Place Youngstown, Ohio,
Building Saint John's Episcopal Church,
323 Wick Avenue.
Persons Interested Mr. William J. Hitchcock, Jr., 1123 Union National Bank
Building; and John W. Ford, Treasurer of Church, 1124 Union National
Bank Building.
Minister The Reverend J. H. Burt.
Denomination Episcopal.

Position in Church 10 clerestory circles (5 each side).

**SUGGESTIONS FOR THE CLERESTORY WINDOWS IN THE NAVE OF ST. JOHN'S CHURCH
AT YOUNGSTOWN BASED ON PHRASES FROM THE BOOK OF PSALMS.....**

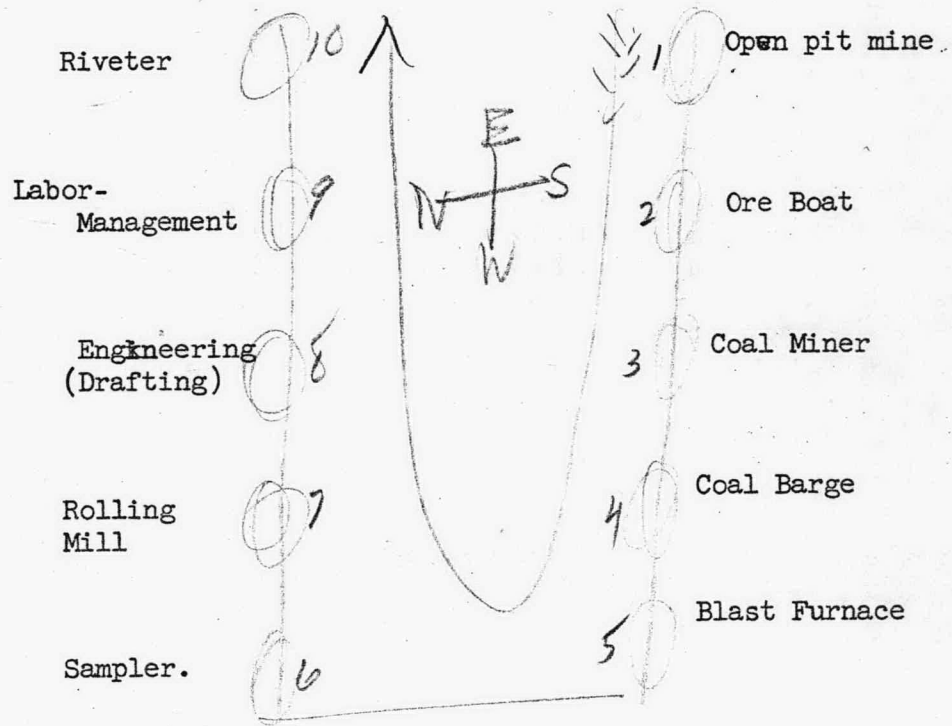
Number One. We are not satisfied with your treatment of the open pit mine. Mr. Hitchcock suggests that you might show a man at the controls of one of the large shovels which does the digging. This would give a sense of work in operation. I think there are pictures of some of these shovels among the pictures in your possession. You are right in assuming that nearly all the work is done by shovels loading directly into the cars. Of course, in an earlier day, there was pick and shovel work by hand but that is now a thing of the past.

Number Two. You will be interested to know that although you have not sent us a sketch of this window, showing an ore boat on the lake, many people think your coal barge window depicts this. Perhaps the "wheel house" treatment in the latter window would work better in the ore boat window.

Number Four. The coal barge needs reworking for the reasons stated in Number Two. I cannot suggest how this needs to be done but the present treatment does not seem to speak even to those who know the operation.

Number Six. We like this general treatment but there are general details that need reworking, such as the way in which the steel is poured forth.

Number Nine. The labor-management council is also one of my favorites though the central character needs straightening up a bit.

Number Ten. The erection of steel girders seems to be seriously in error as far as your picture of a riveting hammer is concerned. I believe you are showing a pneumatic hammer such as is used to break up concrete. A riveting hammer is smaller and is applied in a direct perpendicular to the girder. Moreover, it is small enough to be held in the hands of the operator.

The principal changes were in the first and second windows. We took parts of earlier studies and combined them in this sketch. I do not think the workman or the crane are quite as good as they were in these other sketches, but we will have them at hand for reference in the development of the full size drawings and the actual glass.

The second one is entirely new, and follows the latest suggestions to represent a man on watch in the bow of a Lake ship, with another more complete iron ore vessel in the background. We think this will work out very effectively. See notes about this below.**

**The Second window depicting the sailor on the ore-boat might be improved by giving a little more suggestion of the fact he is on the bridge of the ship and the prow of the vessel in the distance might be reworked to look a little more like an ore-boat. I realize that we are not trying to be photographic in these windows but the representations of the boats as you have done them in the drawing might raise an eyebrow or two for they are rather unlike the freighters that the people in this part of the country know so well. (See illustration sent by the rector) on back of sketch.)

***I also think that a slight change in the number ten window to show the workman holding a riveting hammer the way it must be held if it is to function properly would be good. The right hand holds the handle while the left hand supports the riveting hammer from underneath." (See illustration sent by the rector - on back of sketch).
